**SUBMISSION FROM INNER WEST COUNCIL  
TO THE DEPARTMENT OF PLANNING INFRASTRUCTURE AND ENVIRONMENT  
ON THE SYDNEY METRO WEST ENVIRONMENTAL IMPACT STATEMENT  
(CONCEPT & STAGE 1)**

**22 JUNE 2020**

Figure 2 - Proposed foreshore connections (Metro West EIS – Concept & Stage, 1 Figure 7-9)

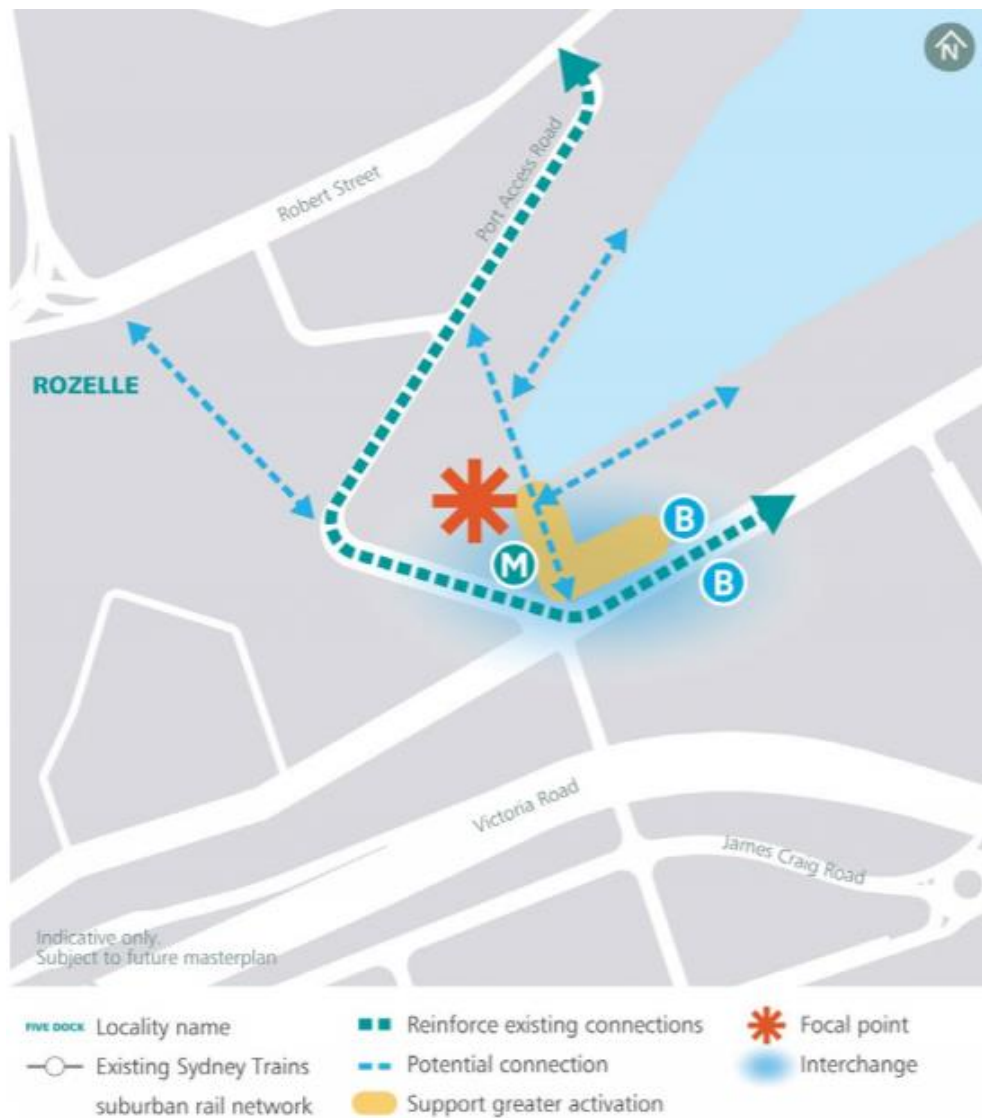
It is considered that the EIS does not clearly demonstrate how the proposed Bays Station will interface with the foreshore. The proposed ‘potential connections’ along the foreshore (as illustrated in Figure 2) are supported.

**Figure 3 – The Bays Station Existing Land Use (Metro West EIS – Concept and Stage 1, Figure 14-10)**

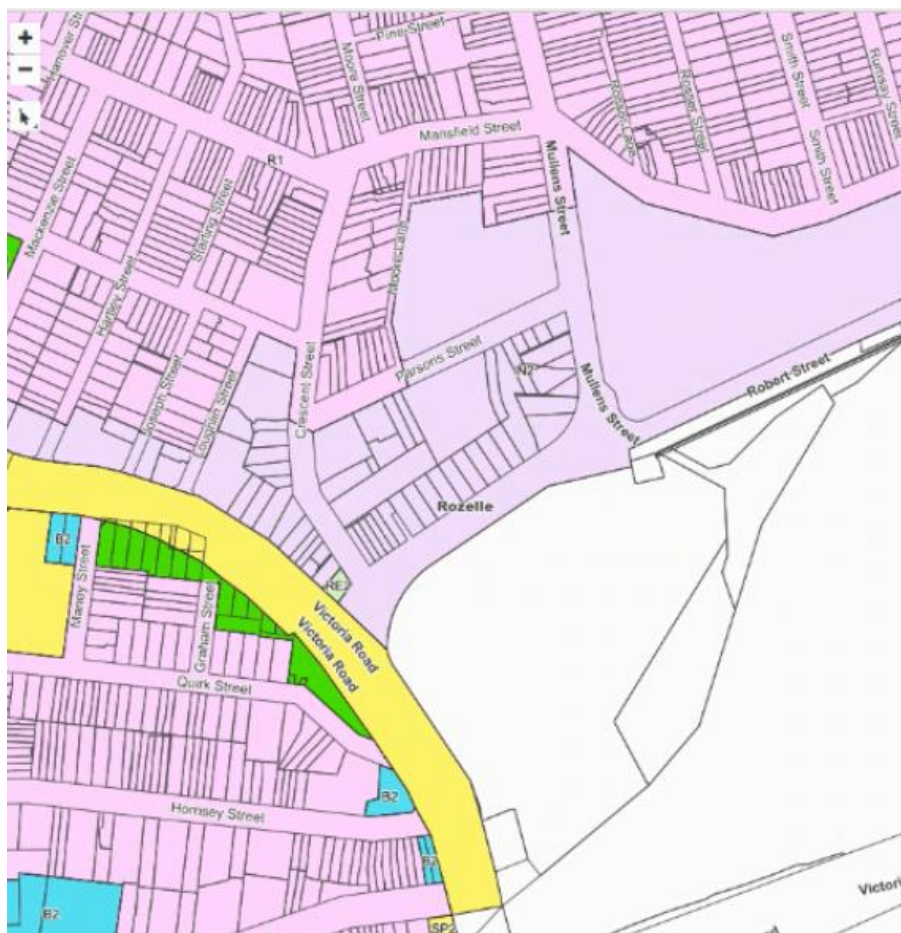
Figure 14-10 of the EIS (Figure 3) indicates existing land uses around The Bays Station, however this figure is inconsistent with the existing zoning under the Leichhardt Local Environmental Plan 2013 (Figure 4).

Council is extremely concerned about the misinterpretation of land use in the area, with industrial zoned sites fronting Victoria Road, Crescent Street, Parson Street and Robert Street being represented as Residential. This illustrated residential use is not reflective of the existing land uses or Council's policy context.

Council therefore requests that the EIS assessment of existing land uses be revised and that, as well as the existing zoning, Council's Draft Employment and Retail Lands Strategy be considered in this assessment.
